Access Compliance Report

Public Rights-of-Way

(Curb Ramps)

Intersection ID: 47252	Main Street: GOOSEBERRY_RD	Cross Street: RASPBERRY_KNOLL_DR	Location: W
ADA ID: 23C70B4CAF9F	Ramp Type: PerpDiag	Initial Pass/Fail: Fail	Overall Compliance: No
Severity Score: 21.25			
Codes/Mitigation Info/Possible Solution		Field Measurements/Component Compliance

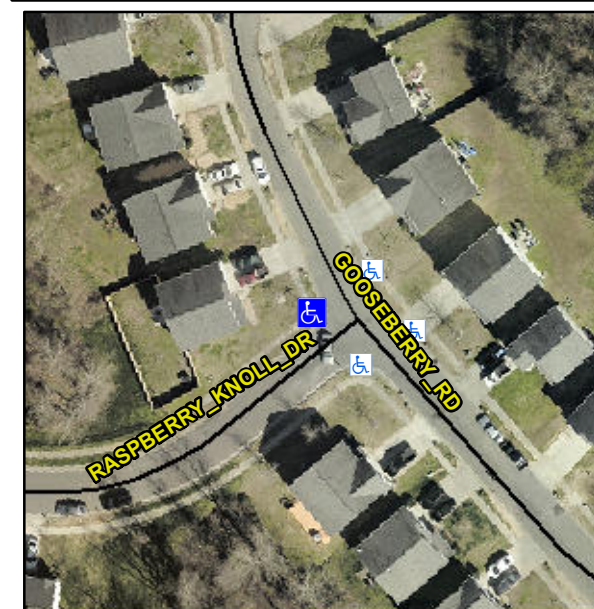
Not Found, R304.5.1, R304.5.3

Compliance	Description	Data	Compliance	Description	Data
N/A	Ramp Length (in)	47.5	Yes	Ramp Slope (%)	7.4
No	Ramp Width (in)	40.0	No	Ramp XSlope (%)	6.2
N/A	Flare Type LT	N/A	N/A	Flare Type RT	N/A
N/A	Flare Slope LT (%)	N/A	N/A	Flare Slope RT (%)	N/A
N/A	Flare Traversable LT?	N/A	N/A	Flare Traversable RT?	N/A
N/A	Landing Length (in)	N/A	N/A	DWS Provided?	N/A
N/A	Landing Width (in)	N/A	N/A	DWS Contrast?	N/A
N/A	Landing Slope (%)	N/A	N/A	DWS Length (in)	N/A
N/A	Landing X Slope (%)	N/A	N/A	DWS Full Width?	N/A
N/A	Landing Curb? (Y/N)	N/A	N/A	DWS Offset (in)	N/A
N/A	Shared Landing?	N/A			
N/A	Gutter Ponding?	N/A	N/A	Gutter Slope (%)	N/A
N/A	Gutter Lip Ht (in)	0.5	N/A	Gutter X Slope (%)	N/A
N/A	Painted X Walk1?	No	N/A	Painted X Walk2?	No
	X Walk 1 Direction	To SE		X Walk 2 Direction	To NE
N/A	X Walk 1 Width (in)	N/A	N/A	X Walk 2 Width (in)	N/A
	X Walk 1 Slope (%)	1.3		X Walk 2 Slope (%)	2.1
	X Walk 1 X Slope (%)	2.9		X Walk 2 X Slope (%)	3.8

Remove & Replace Curb Ramp With Two New Directional Ramps or Equivalent.
